Access Compliance Report

Public Rights-of-Way

(Curb Ramps)

Intersection ID: 12928	Main Street: PENMAN_ST	Cross Street: QUINCEY_ST	Location: W
ADA ID: 2C7F695CAF2A	Ramp Type: PerpDiag	Initial Pass/Fail: Fail	Overall Compliance: No
			Severity Score: 13.75

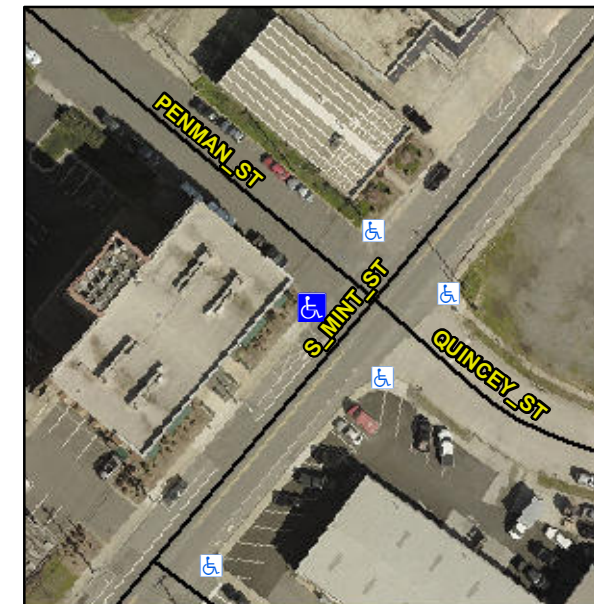
Not Found, R304.2.2, R304.5.3

Compliance	Description	Data	Compliance	Description	Data
N/A	Ramp Length (in)	27.0	No	Ramp Slope (%)	10.1
Yes	Ramp Width (in)	48.0	No	Ramp XSlope (%)	2.5
N/A	Flare Type LT	N/A	N/A	Flare Type RT	N/A
N/A	Flare Slope LT (%)	N/A	N/A	Flare Slope RT (%)	N/A
N/A	Flare Traversable LT?	N/A	N/A	Flare Traversable RT?	N/A
N/A	Landing Length (in)	N/A	N/A	DWS Provided?	N/A
N/A	Landing Width (in)	N/A	N/A	DWS Contrast?	N/A
N/A	Landing Slope (%)	N/A	N/A	DWS Length (in)	N/A
N/A	Landing X Slope (%)	N/A	N/A	DWS Full Width?	N/A
N/A	Landing Curb? (Y/N)	N/A	N/A	DWS Offset (in)	N/A
N/A	Shared Landing?	N/A			
N/A	Gutter Ponding?	N/A	N/A	Gutter Slope (%)	N/A
N/A	Gutter Lip Ht (in)	N/A	N/A	Gutter X Slope (%)	N/A
N/A	Painted X Walk1?	No	N/A	Painted X Walk2?	No
	X Walk 1 Direction	To SE		X Walk 2 Direction	To NE
N/A	X Walk 1 Width (in)	N/A	N/A	X Walk 2 Width (in)	N/A
	X Walk 1 Slope (%)	6.0		X Walk 2 Slope (%)	3.1
	X Walk 1 X Slope (%)	0.2		X Walk 2 X Slope (%)	1.4

Remove & Replace Curb Ramp With Two New Directional Ramps or Equivalent.
